# Highland Lakes Elementary Proposed BMP Improvements

Project: Highland Lakes ES Drive Lane Pond Improvements

We've prepared the following summary of LCRA Water Quality BMP Improvements that have been required for previous and current development on the Highland Lakes Elementary School Site. Note that current LCRA requirements significantly exceed BMP designs provided for previous development on the site. Refer to Attachments A-C for plans previously approved by LCRA. During review of the currently proposed site improvements, LCRA also required additional levels of design detail with direct cost implications. Refer to Attachments D-F for design progression through LCRA review. Refer to Attachment G for LCRA Comment Response Letters. Refer to Attachment H for Additional Required LCRA Permit Documentation. Some requests from LCRA, including an underdrain system in Pond 2, were waived through coordination during site review.

**Attachment G: LCRA Comment Response Letters**

POND PLANS &  
PROFILES

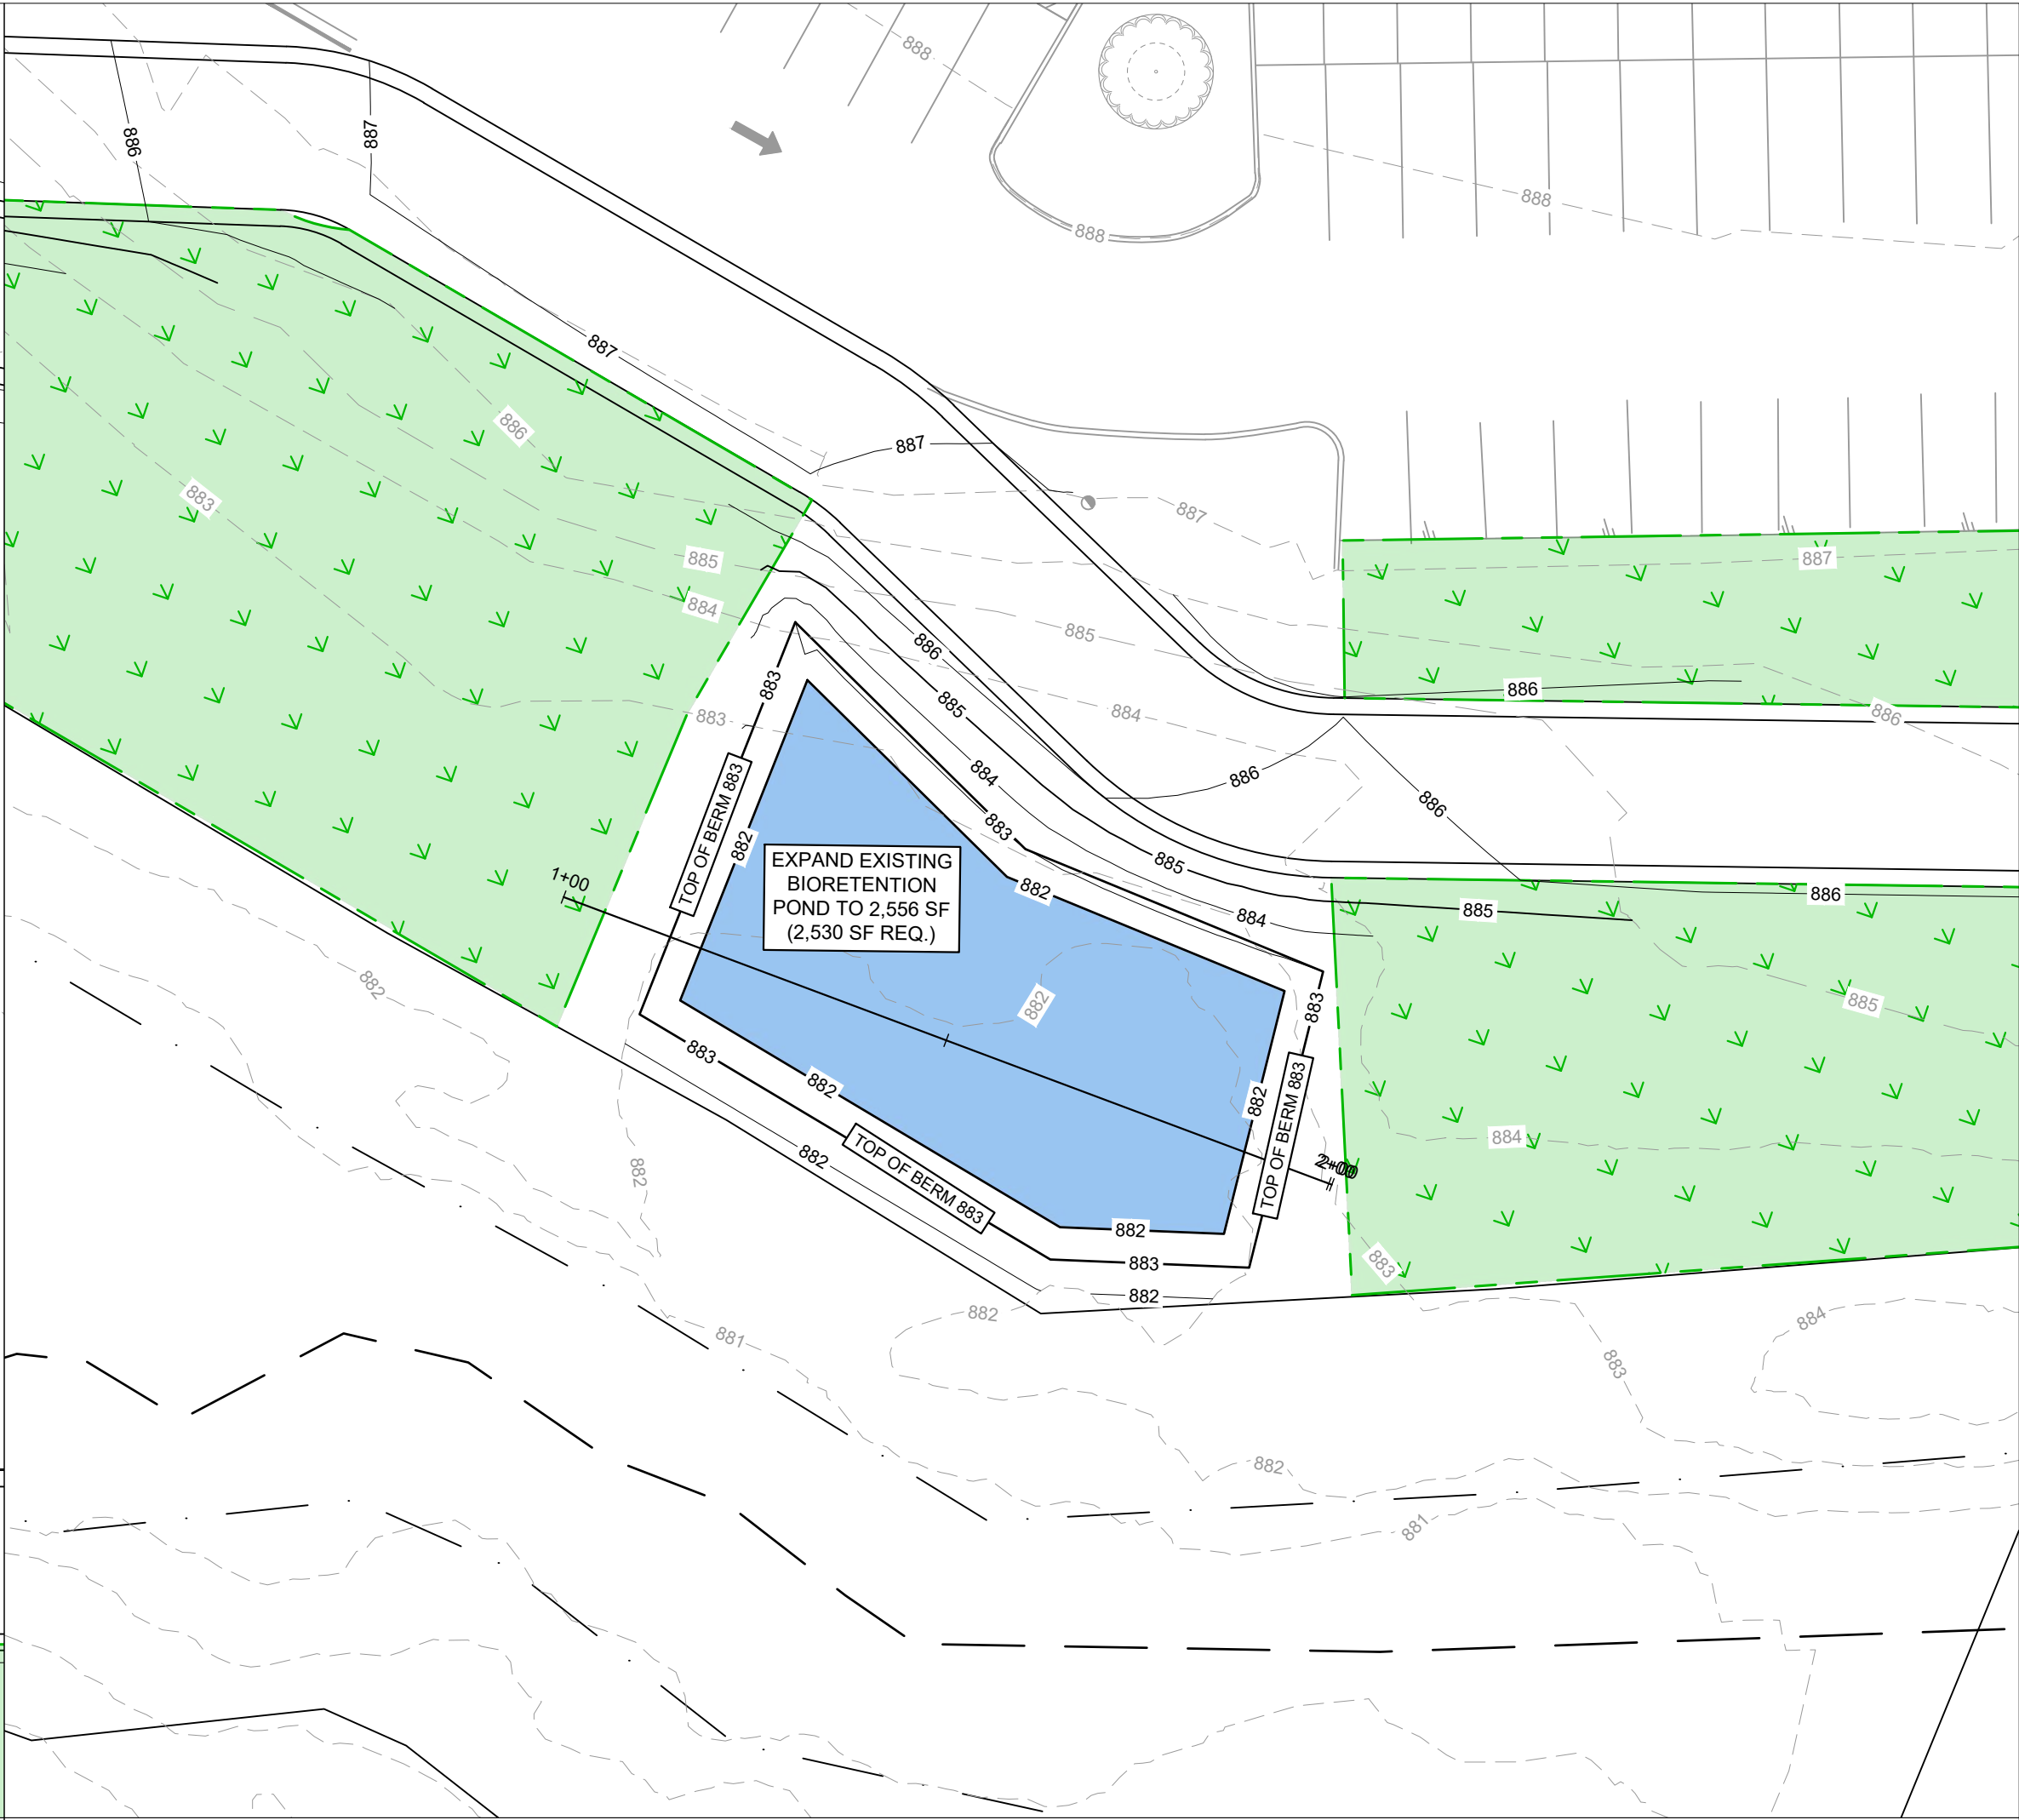
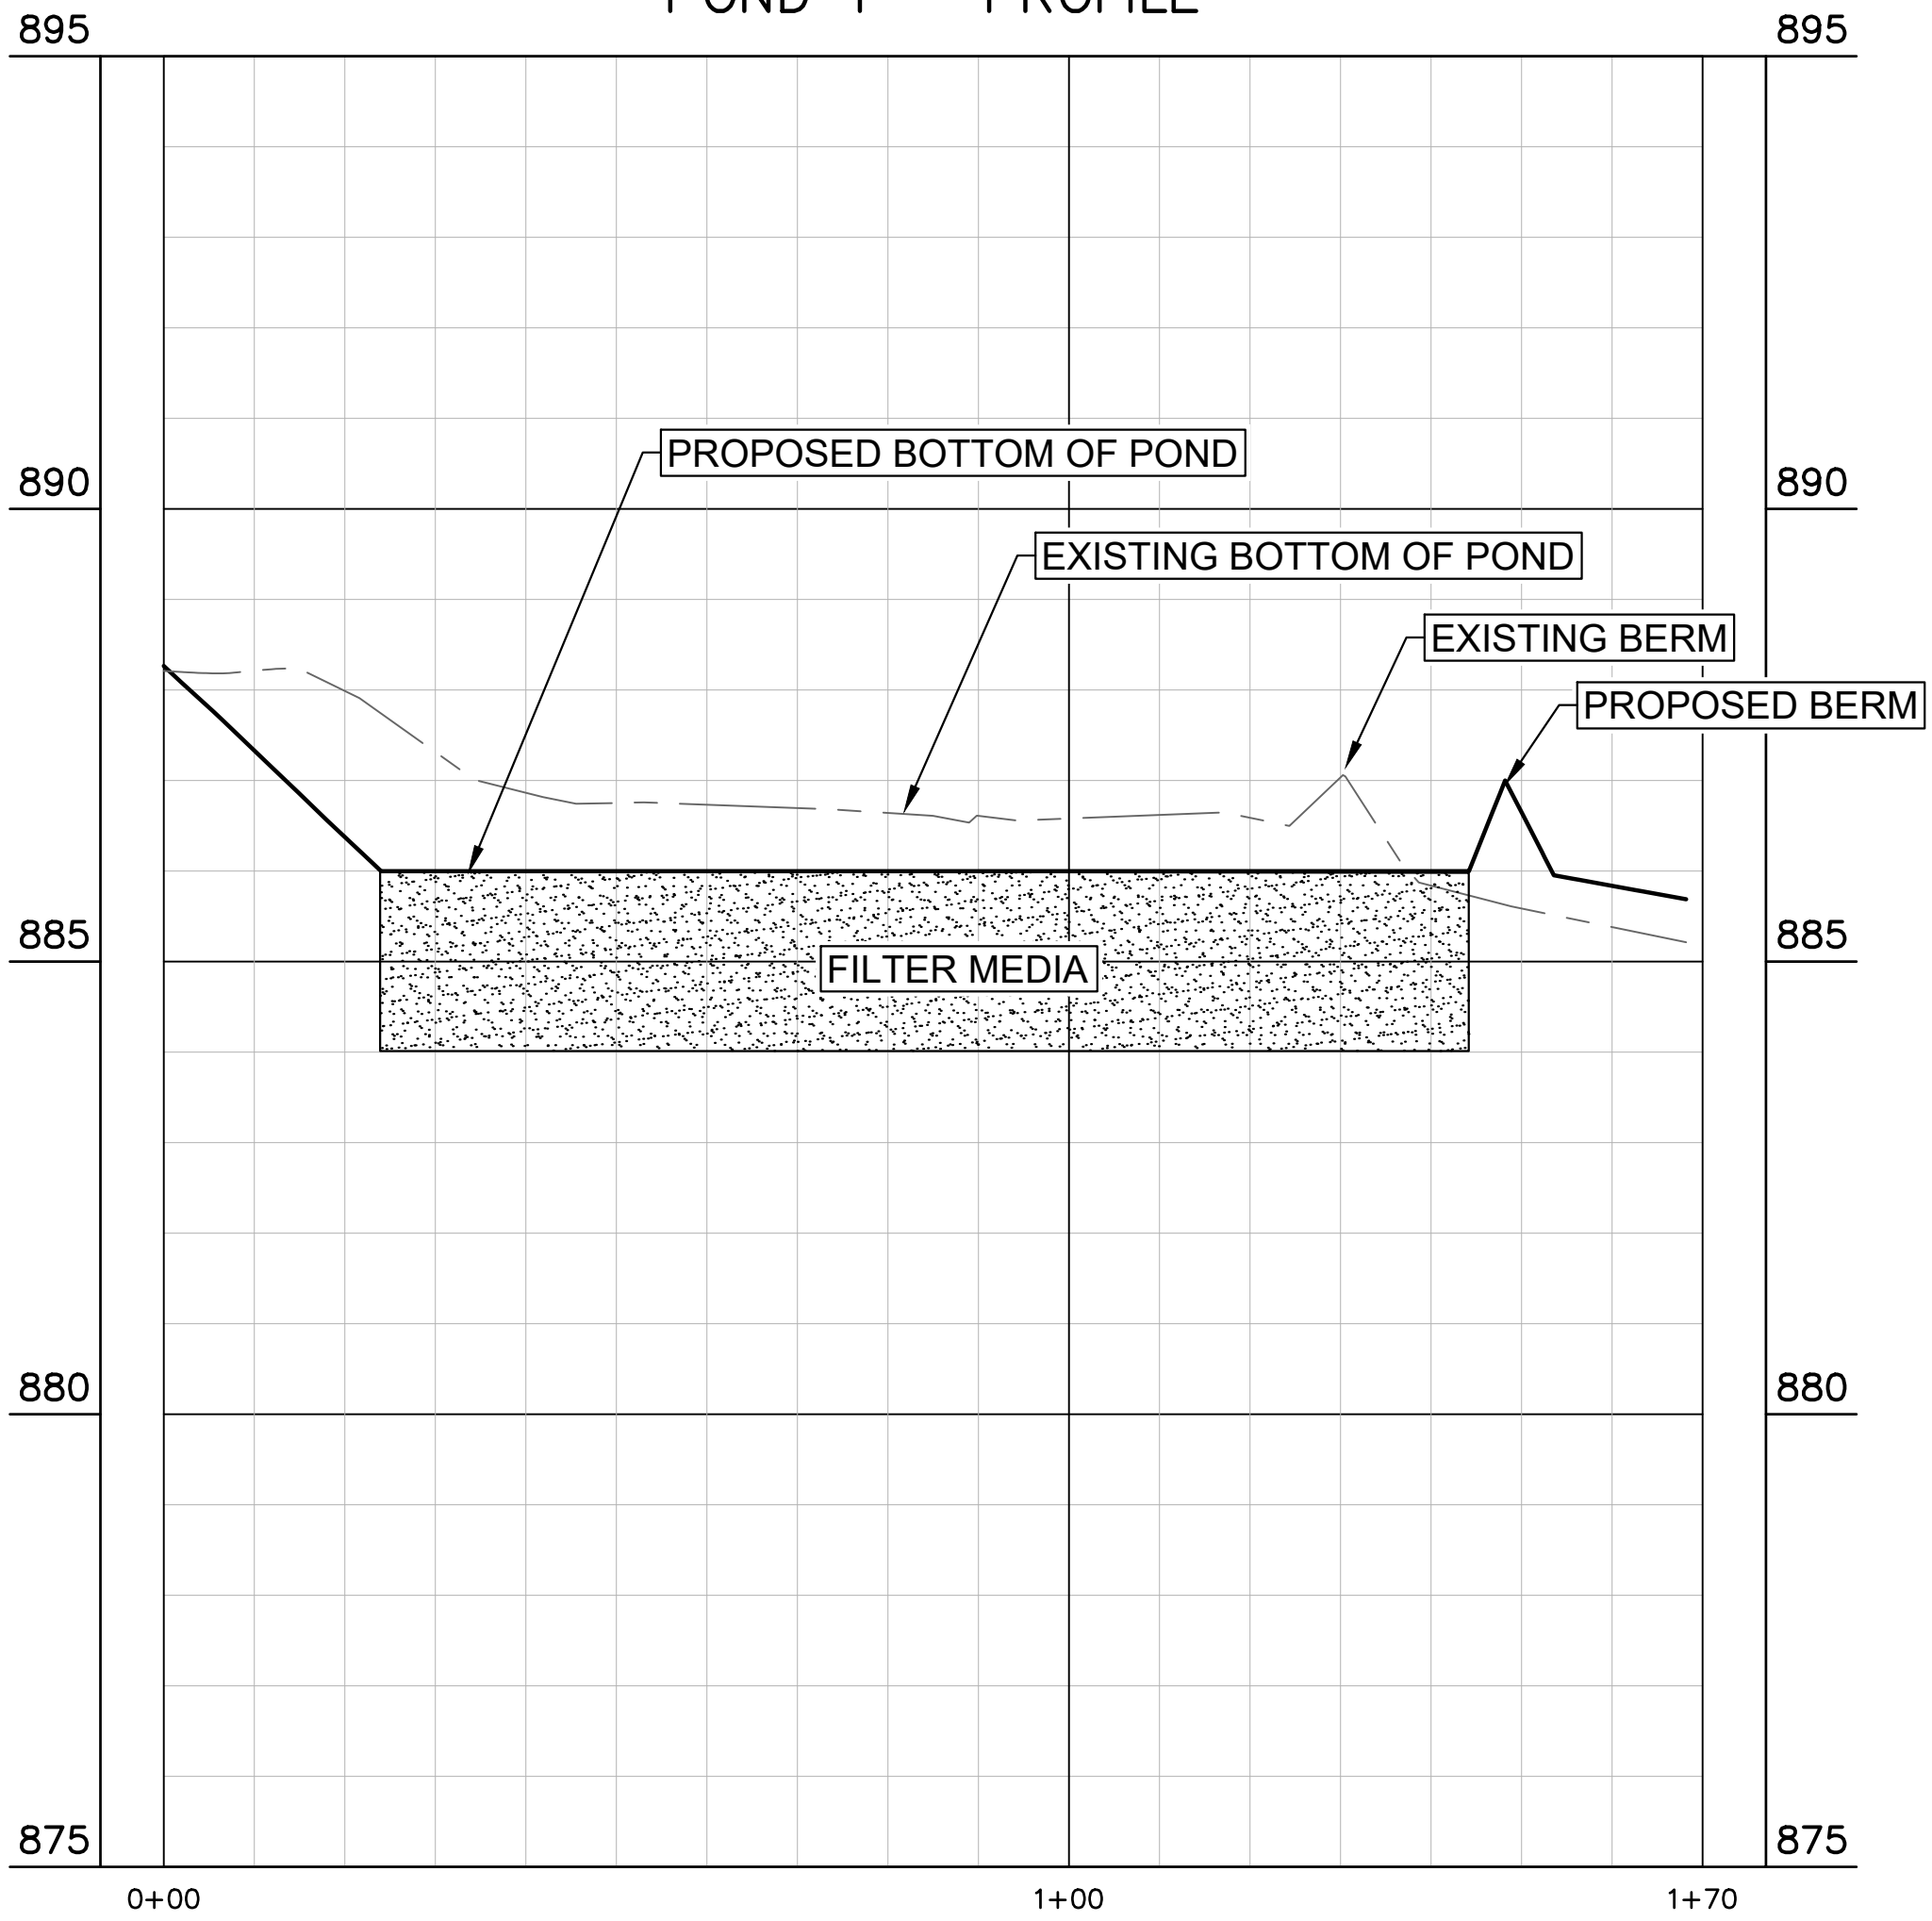
U2 – Comment partially addressed. Please adjust or provide the following for Pond 1:

1. Verify that all flowlines within the bioretention basin are at the same elevation.
2. Verify that all piping is perforated 6" SCH 40 PVC with 3/8" perforation and add FL callouts.

3. Provide cleanouts for all underdrains within the basin and provide a cleanout detail.
4. An orifice of 1" minimum diameter on the underdrain outfall is required. Please see sheet 172 for the requirement and sheet 177 of the HLWO technical manual to calculate the true orifice diameter. Please make sure to provide a callout specifying the orifice diameter and provide an orifice detail (threaded cap, etc.).

5. For the inner basin underdrain system please provide at least one cleanout above the WQV elevation.
6. Provide culvert discharge velocities used to calculate the riprap and add the riprap size to the call-out.

7. The top of the rock berm only needs to be at the WQV EL. Also, provide a rock berm detail or specify the following types of wire for the berm detail provided "metallic-coated or PVC-coated steel with a minimum wire size of 14 gauge (0.080 inch or 2.0 mm diameter)."

3. Cleanouts are provided at the start of each underdrain lateral. An LCRA detail is provided in the Water Quality Details & Notes plan sheet. Please confirm if this meets LCRA requirements.

4. The true orifice diameter was calculated through applying the formula on sheet 177 of the HLWO technical manual. These calculations, as well as, the equation, for reference, have been provided on Pond 1 Plan & Profile plan sheet. A threaded cap with 1.2" orifice is called out at the underdrain outlet.

6. The concrete channel discharge velocity, along with the rip-rap calculations for the flow entrance and outfall have been added to the Pond 1 Plan & Profile plan sheet. The rip-rap size has been added to the callouts.

7. The rock berm has been adjusted to be at the water quality elevation of 887.00'. The detail provided on Pond 1 Plan & Profile plan sheet shows the rock berm being 14" in height, with 2" being underground. A callout with the type of wire options to be used has also been added to the detail.
